Florida Gateway College
Public Safety Complex
Engineer's Project Number L180401FGC

Addendum # 1:

9 VEHICLE OPP. TRACK PAVEMENT DESIGN
C60 SCALE:N.T.S.

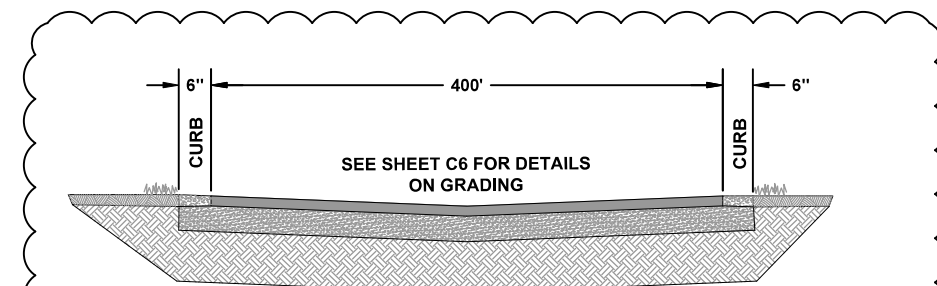
4. *9/C60 Detail for Vehicle OPP Track calls for 2 lifts
Bottom lift @ 1.5" SP TL-C
Q Clarification. This mix is an SP 12.5 and does not require PG 76-22
This lift shall be SP 12.5 and does not require PG 76-22. (see revised plan sheet)
Top lift @ 1.25" SP TL-C with PG 76-22
Q Clarification: This is an SP 9.5 not an FC 9.5
This lift shall be SP 9.5 with PG 76-22. (see revised plan sheet)*

12" TYPE B STABILIZATION
 8" LIMEROCK BASE LBR 100
 TYPE SP 12.5 (TL-C) 1.5"
 TYPE SP 9.5 (TL-C), (PG 76-22) 1.25"
